J A Mooney
Executive Manager
Midland Project Office

July 15, 1983

MIDLAND ENERGY CENTER GWO 7020
RESPONSE TO NRC REGION III QUESTIONS
OF JULY 14, 1983 MEETING
File: 0485.16 UFI: 42*05*22*04 Serial: CSC-6792
12*32

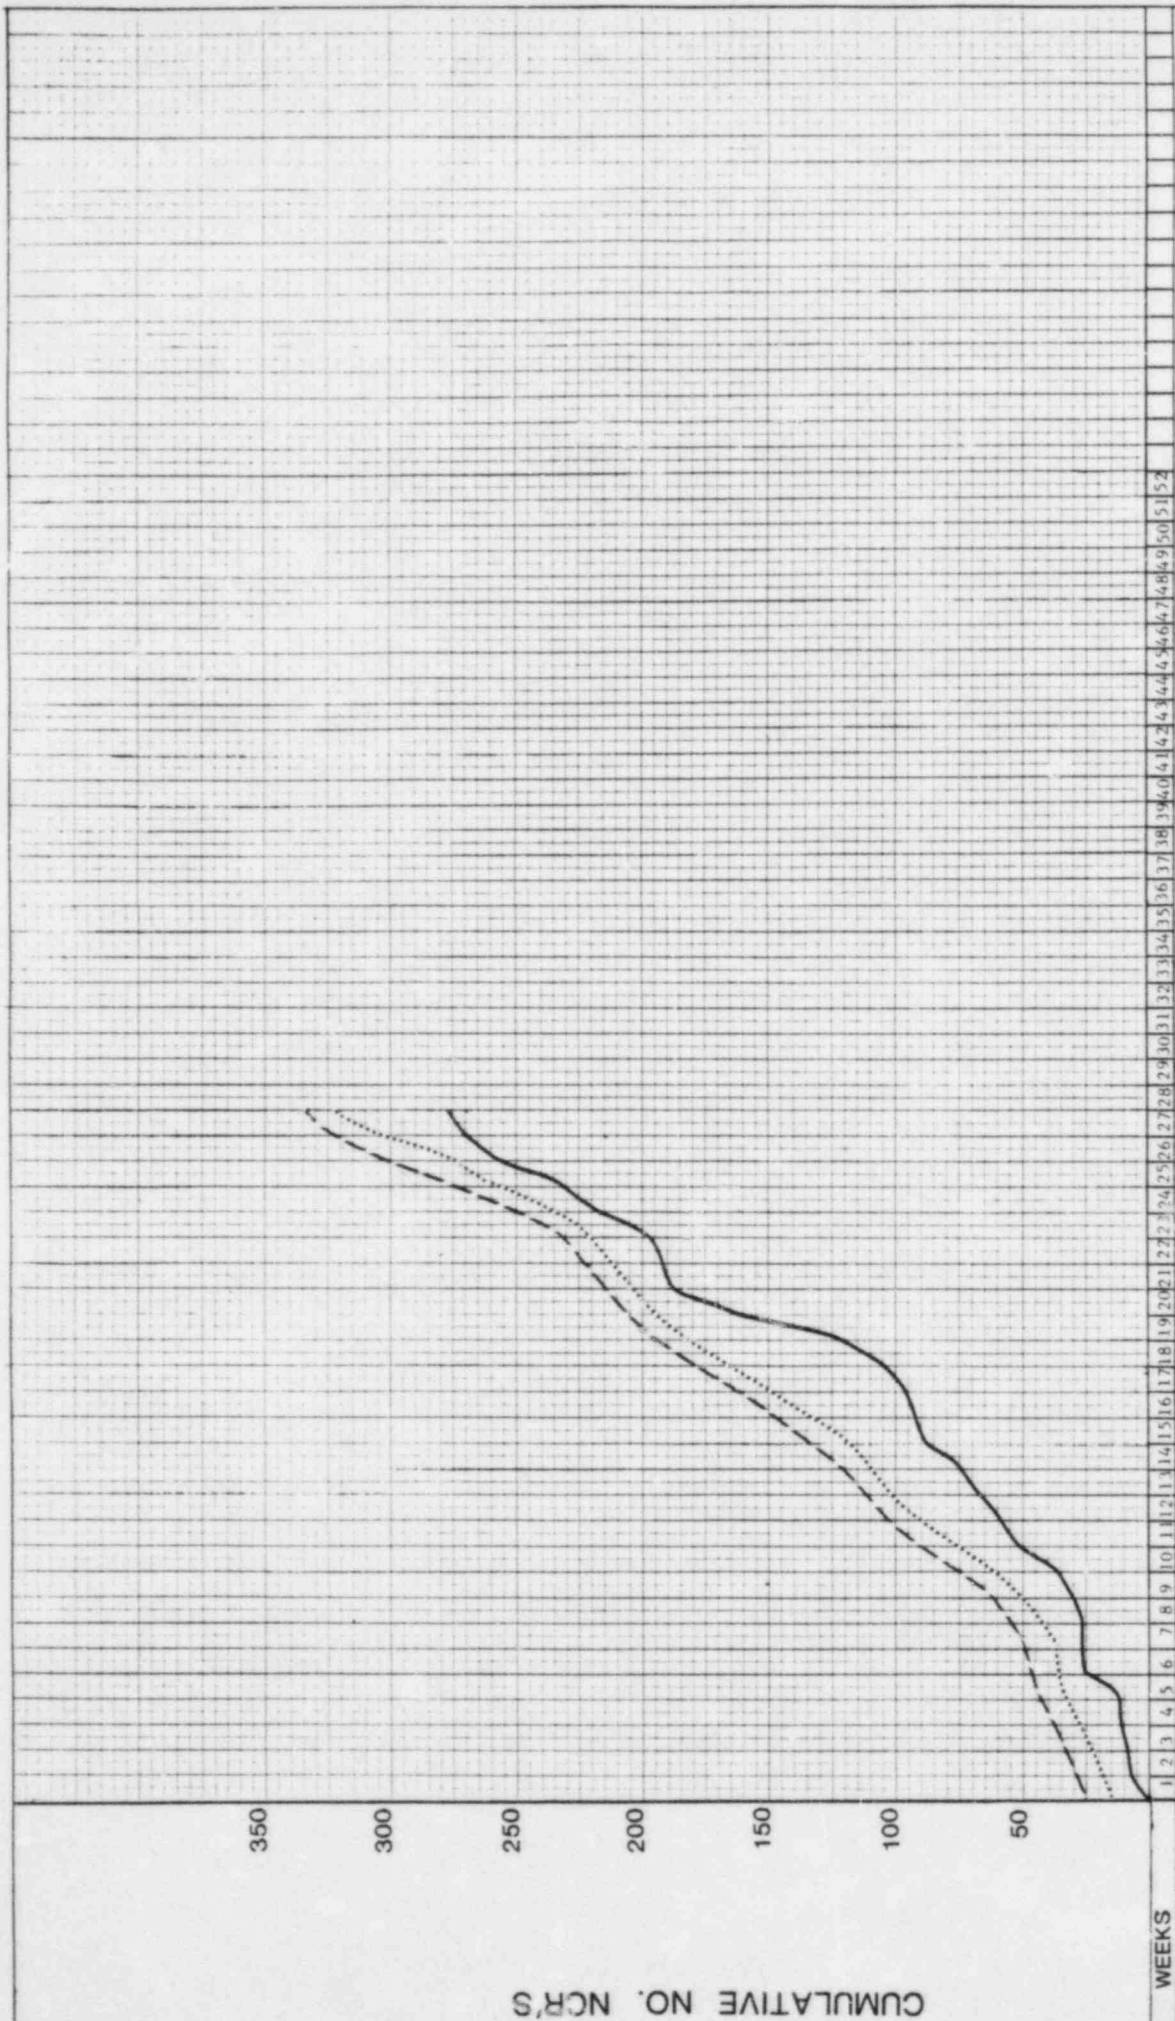
Concern: Timely resolution of outstanding NCR's continues to be a nagging problem.

Response: A discussion was held with the Region III Staff relative to the number of NCR's issued and time required for resolution (Attachment 1). A program is in place to identify adverse trends and take corrective action. Significant improvements have been realized as evidenced by the attached charts and considerable emphasis is being placed in these areas by all Soils Remedial Organizations to improve the results. Personnel have been assigned the responsibility in each action organization to coordinate responses and make sure that follow-up commitments are made within their respective organizations. Action is also taken during the Weekly Project Soils Management Meetings, as required, to assure continuing improvement in addressing quality items and closure of NCR's.

Graph 1: The cumulative number of NCR's is plotted for each week. The broken/slashed line represents all FSO NCR's written. The dotted line represents FSO NCR's written and corrected for those NCR's inherited from the Balance of Plant. These "inherited" NCR's predate the FSO organization and represent long term Non-"Q" soil replacement. The solid line represents the number of NCR's closed.

(3) SHEETS OF SKETCHES
ATTACHED TO THIS REPORT

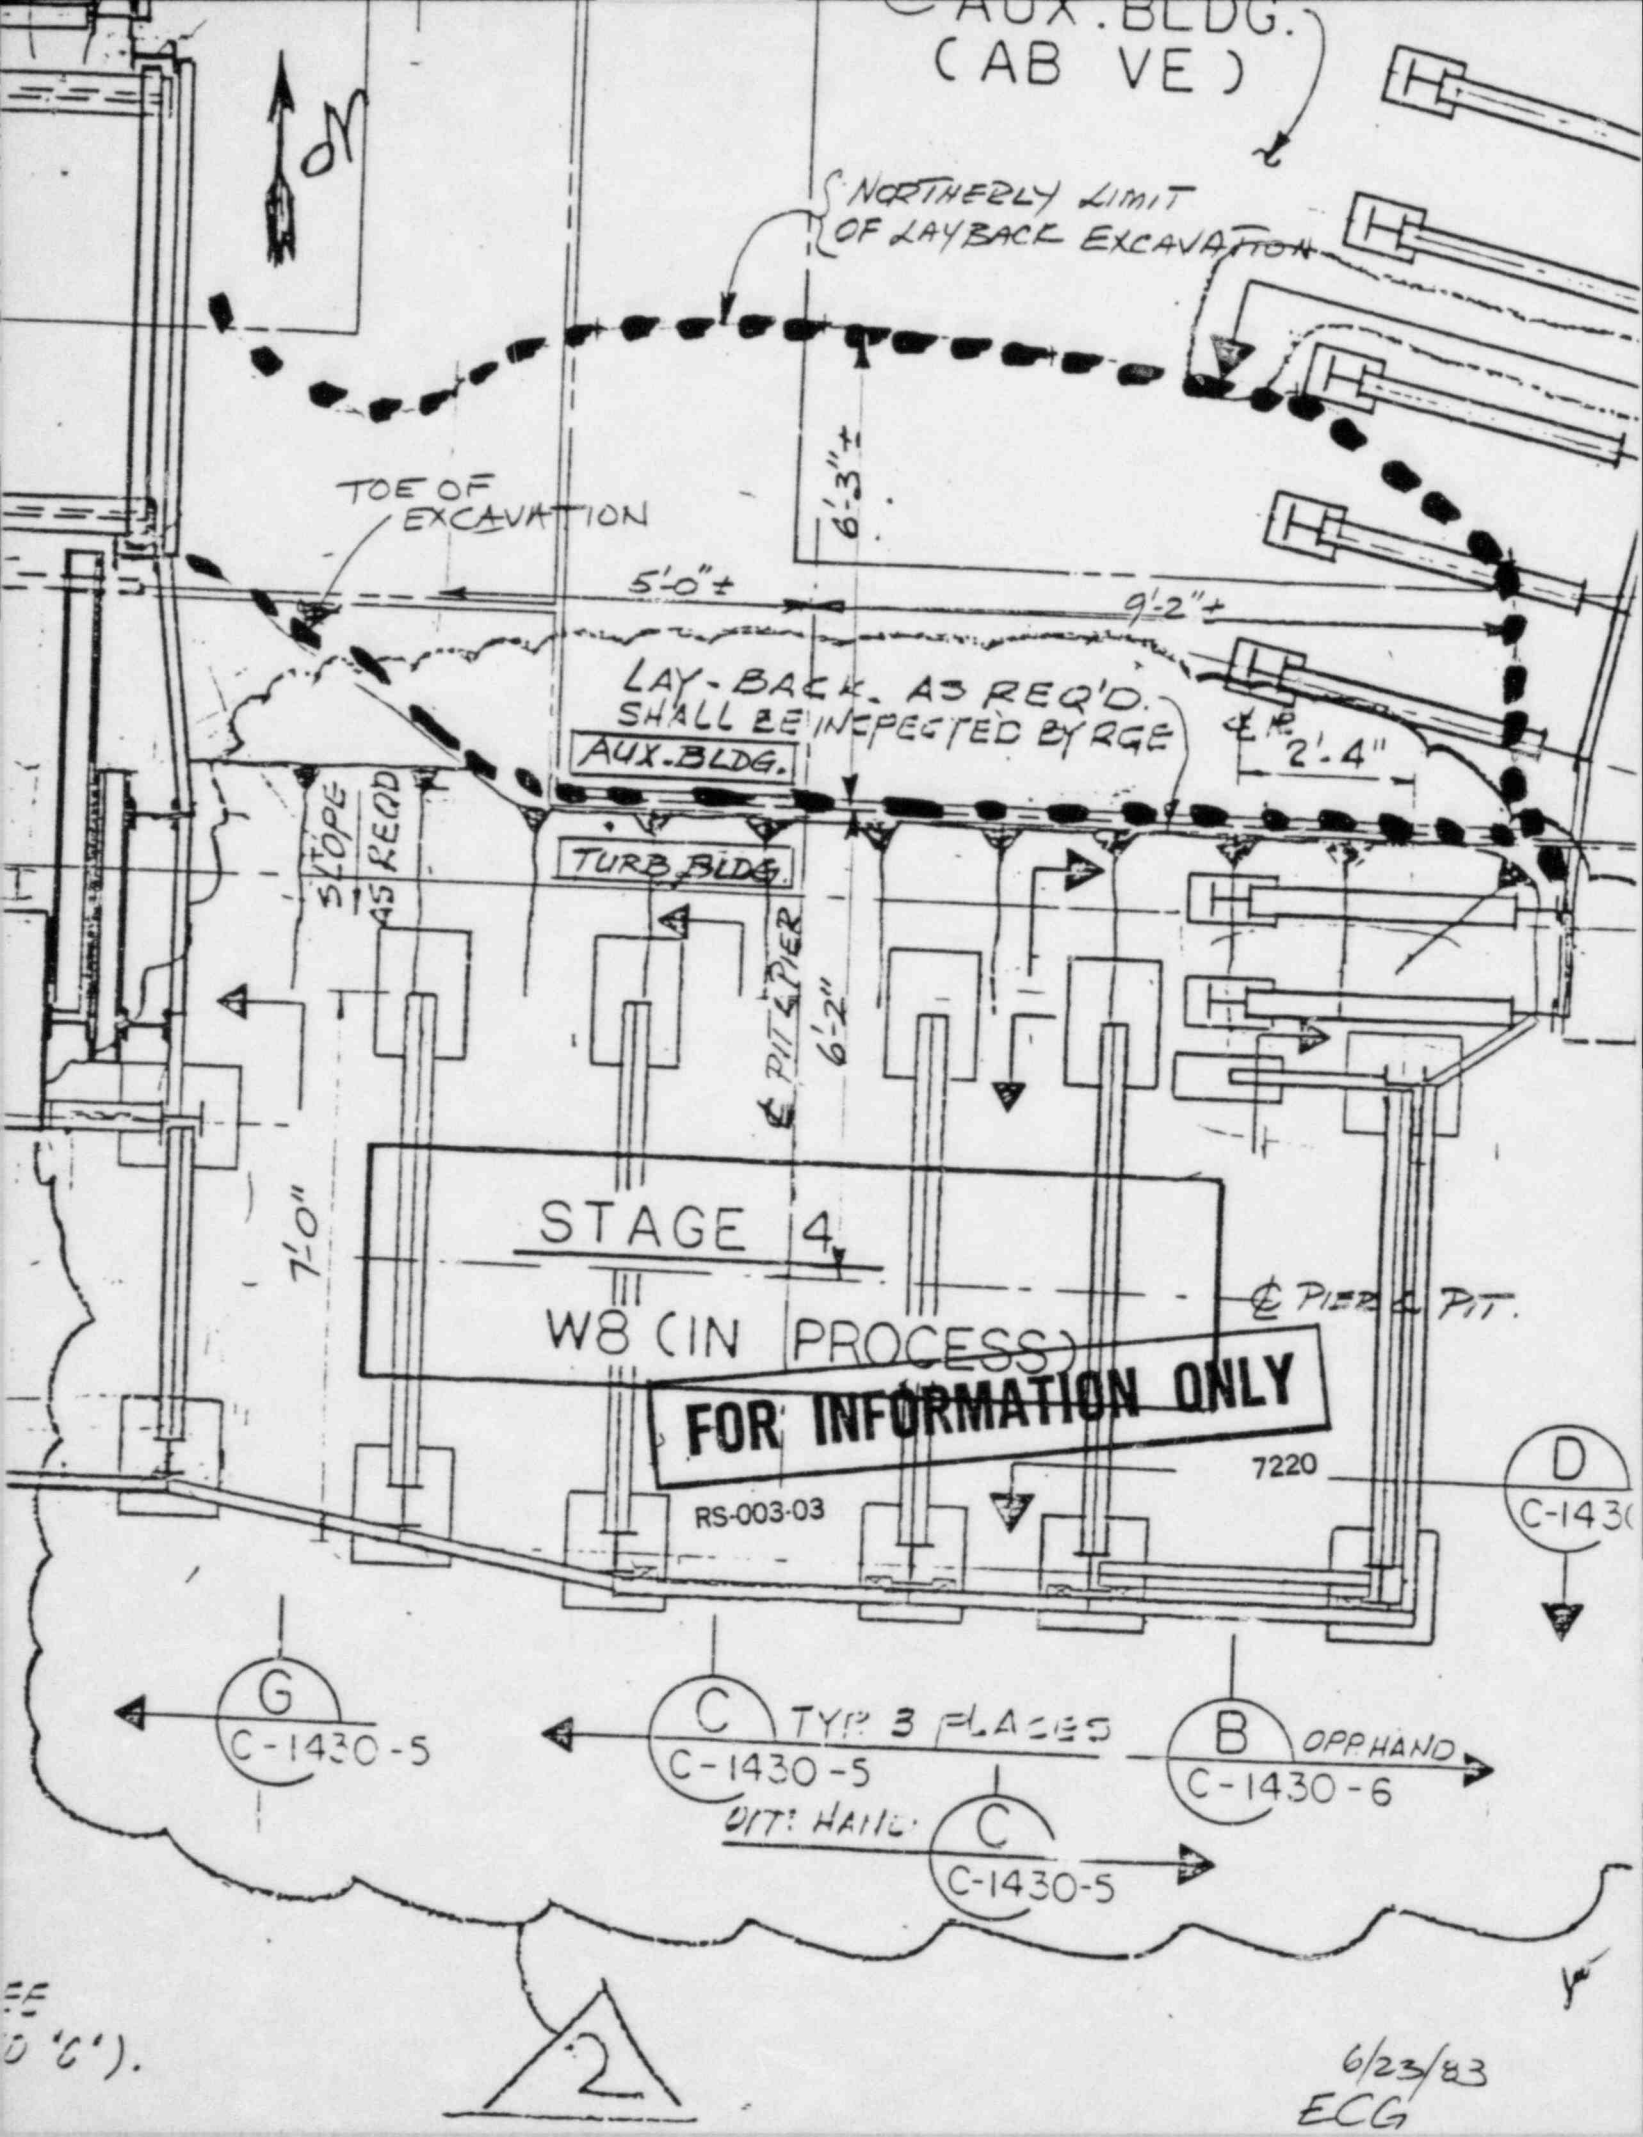
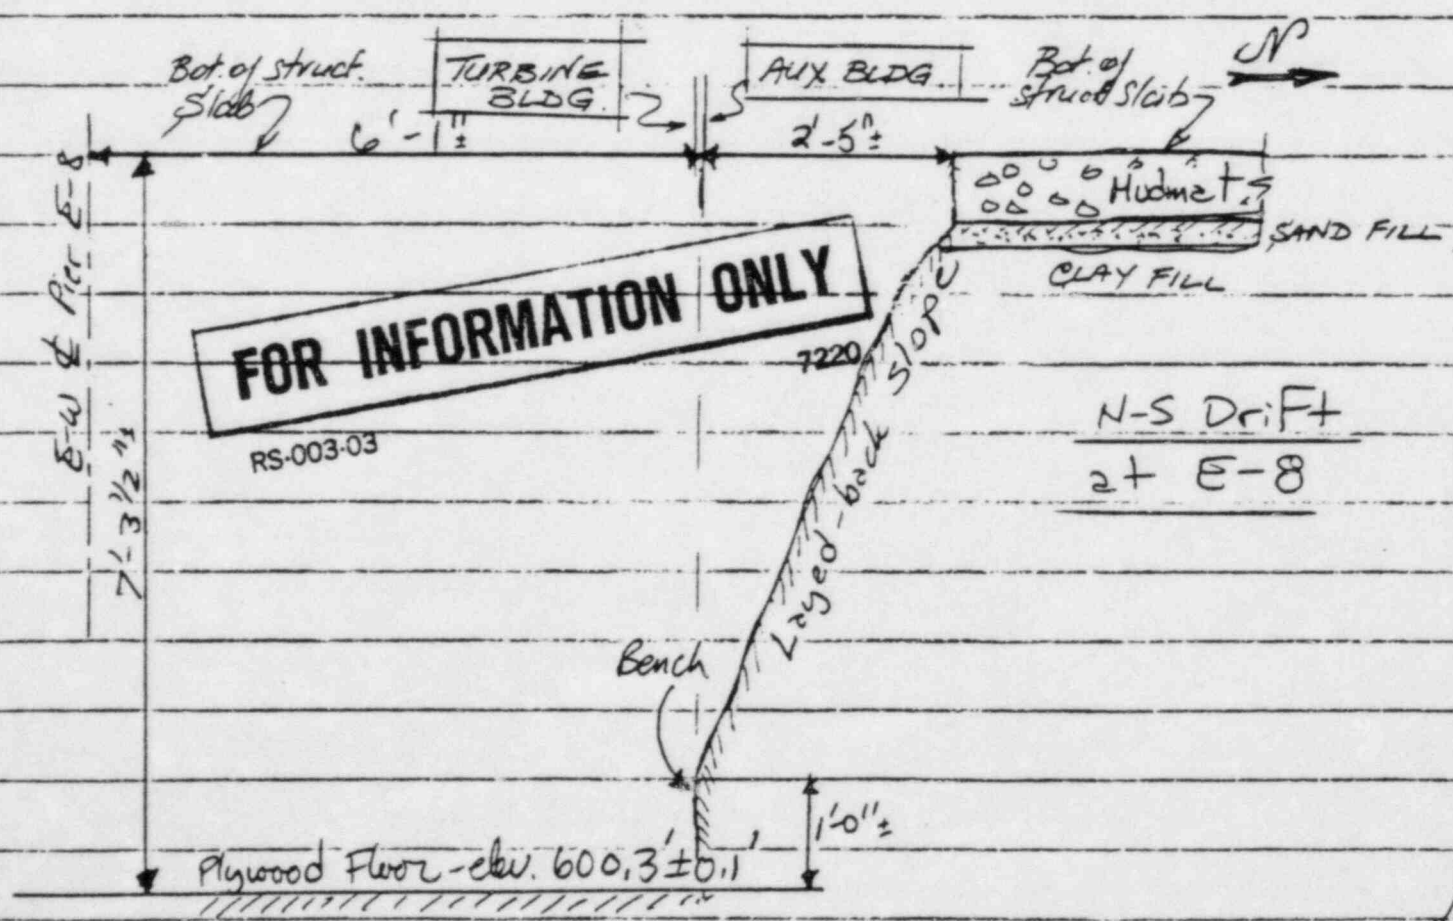
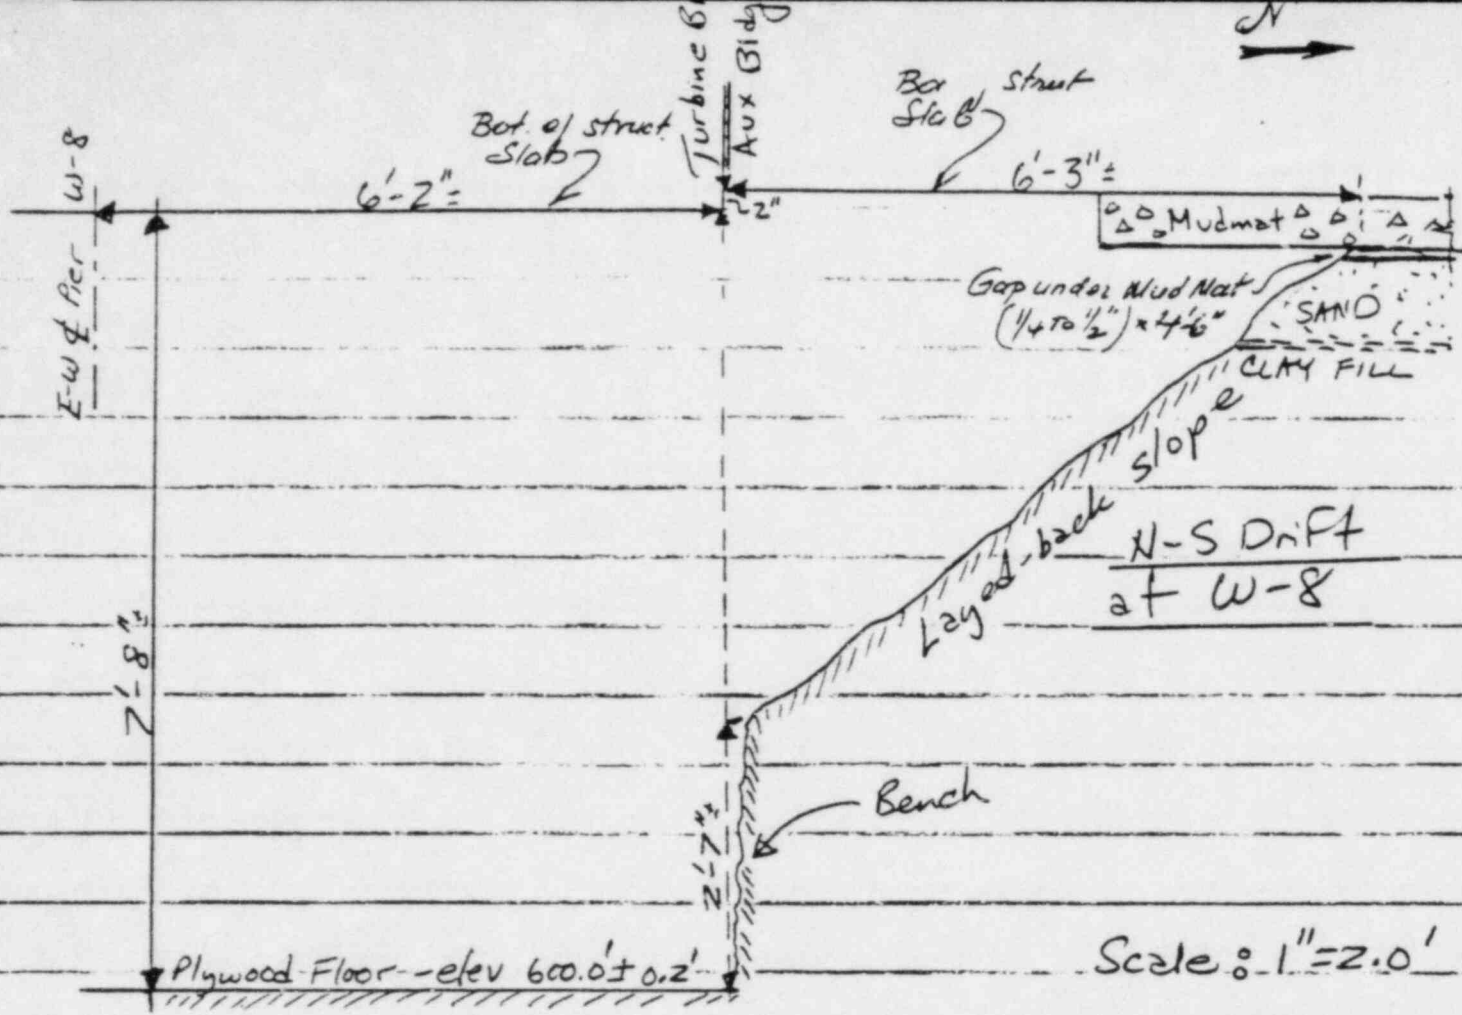
Concern: Grouting of void between existing fill and West Auxiliary Building Foundation.

Response: The attached report (Attachment 2) addresses the grouting of the gap encountered between the soil and the Auxiliary Building Foundation.

- 14) CURING OF THE UPPER TELL - TALE P_2 DRYFACE CONTINUED
- 15) RGE (R COSBY & E GRAY) COMPLETED PREPARATION
OF "AS BUILT" EXTENT OF EXCAVATIONS UNDER AUX
BIDG. ALONG THE NORTH SIDE OF ACCESS DRIFTS
TO PIERS E-B & W-9. TODAY SKETCHES WERE
PREPARED

GROUT PLACEMENT PLAN

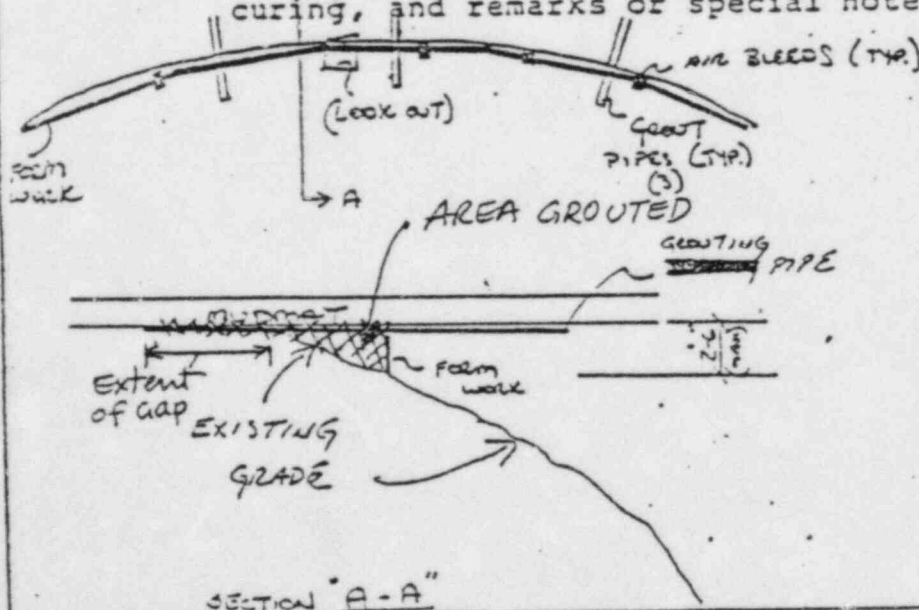
| No. | Description | Remarks |
|-----|---|---|
| 1. | Filled void north of layback area. 180 gals of neat cement grout ($\frac{3}{4}$ water : 1) were used. grout pressures ranged from approx. 20 to 80psi Signed QC IR and stated that RGE concurred with F.E. grouting operation was acceptable. QC hold on bearing PL on knee brace* of 2 nd set | * See sketch attached. * PL improperly Shimmed Sk. on QC tag. |

- ① PIPE LOCATIONS MAY VARY DUE TO RESISTANCE WHILE BEING PLACED.
- ② AIR BLEEDS AS NECESSARY
- ③ OBSERVATION PORTS AS REQUIRED.
- ④ FORMWORK MAY VARY DEPENDING ON SOIL CONDITIONS (ACTUAL).
- ⑤ MAX. SPACING OF GROUT TIES 10'.
